Response to the referee comments (RCs)

Anonymous Referee #1

R: The manuscript provides a long-term datasets of reservoir storage in Mainland Southeast Asia. This is meaningful for studies about the reservoir operations and further studies on hydrological processes. However, there are still some comments needed to be illustrated as listed below.

Figure S1: nRMSE and R² between inferred (Level-0 and Level-1) and observed data. The nRMSE decreased and R² increased from Level-0 to Level-1, suggesting an improvement in the outlier removal approach.

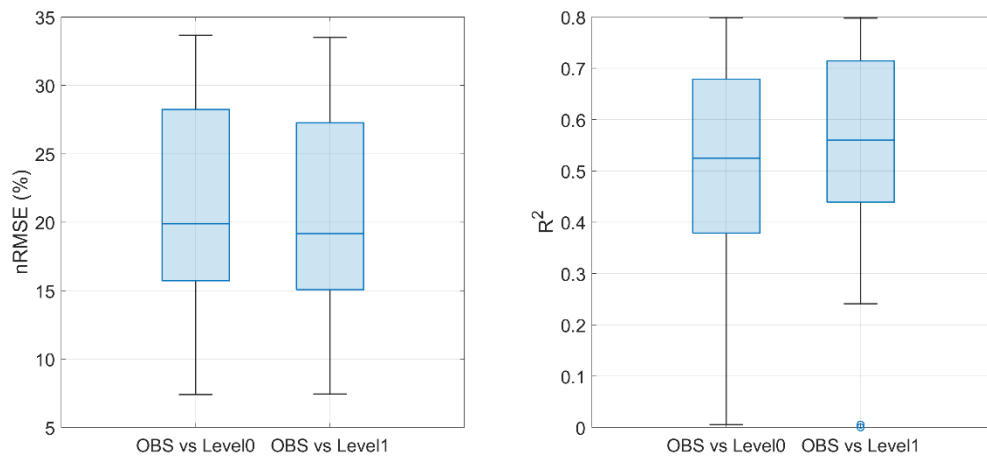
R: Is the estimation improved in level 1 comparing to level 0? If so, how much?

A: Level-1 data are obtained after removing the outlier from the Level-0 data. The improvement in Level-1 compared to Level-0 varies between the reservoirs. To quantify it, we calculated the R^2 and nRMSE for level-0 and level-1 of the 20 reservoirs for which we have observed storage. We found that the nRMSE decreased and R^2 increased from Level-0 to Level-1, suggesting that the outlier removal process can further enhance the quality of the data.

We have added the following figure in the revised manuscript
